Enclosure 1

Written Examination Performance Analysis with Recommended Substantive Changes

Examination Performance Analysis

T1018A CNTMT TEMP 92/766 PRZR ENCL WALL

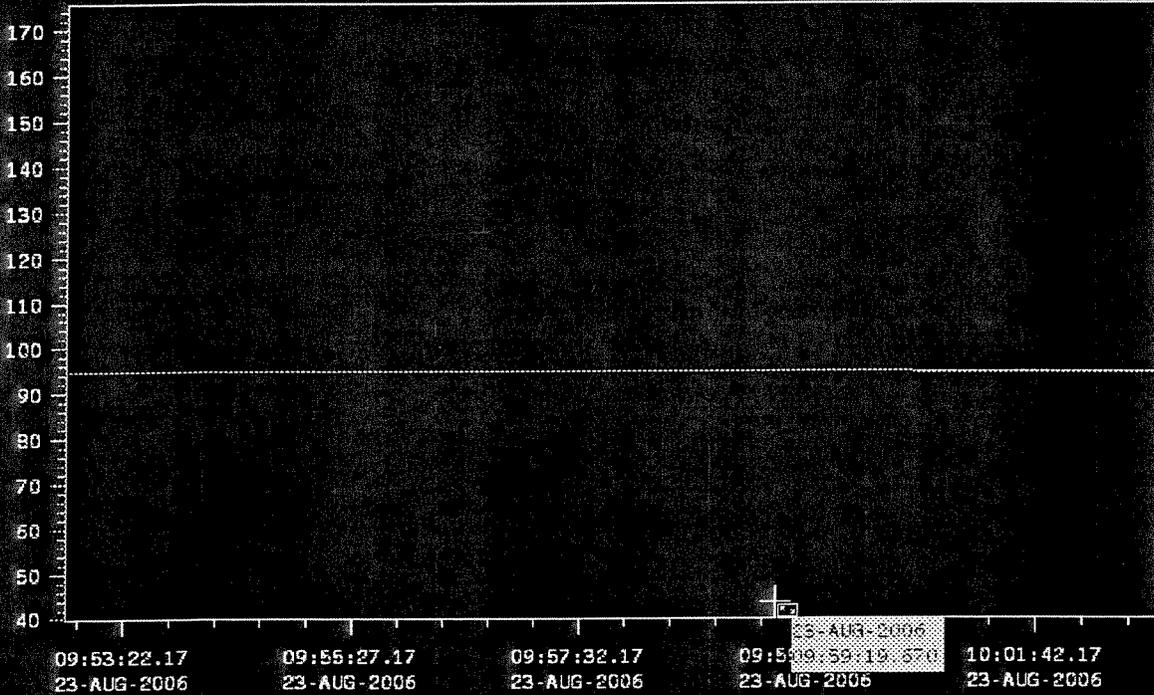
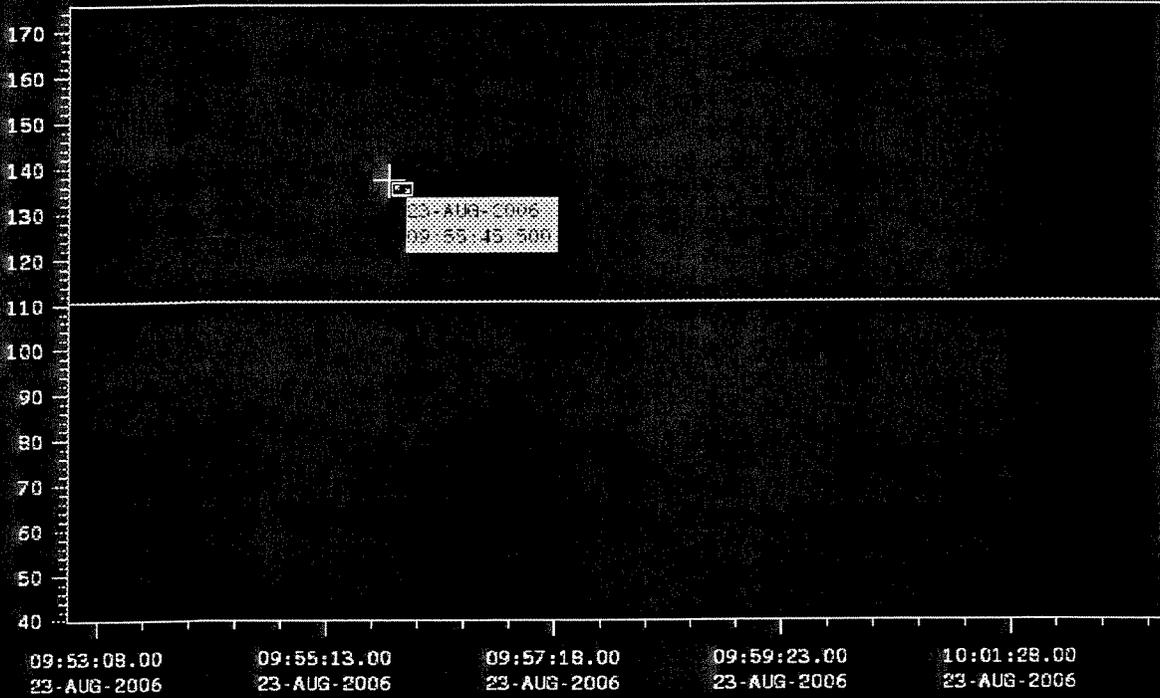
None of the answers are correct.

The question asks for the effect of a rapid increase in Containment Lower Compartment air temperature. Precaution D in SOI-30.03 addresses the changes in pressurizer enclosure temperature. Changes in temperature in lower containment can occur without seeing the same effect in the pressurizer enclosure temperature. Changes in the pressurizer enclosure temperature can occur due to changes in air flow without changing lower containment temperature. See precaution H in the attached SOI- 30.03

The question should have read "*Which one of the following describes the effect of a rapid increase in Pressurizer Enclosure air temperature from 102°F to 125°F over a 10 minute period?*" to get the desired answer.

Delete the question from the test due to technical inaccuracy.

SOURCE

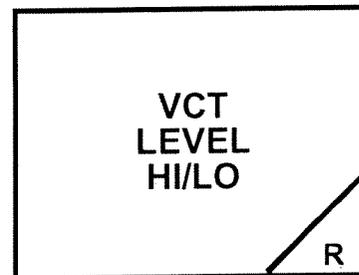
The E-3 procedure would have the charging pump suction realigned to the VCT and automatic make-up available making choice "C" a correct answer.

Adding the failure of 1-LT-62-129 in the stem of the question results in full diversion of letdown flow. Depending on the letdown flow rate and the settings of the automatic makeup flow controllers for dilution and boric acid, the VCT level could continue to drop resulting in having to realign the VCT to the RWST in

Accept both "A" and "C" as correct answers
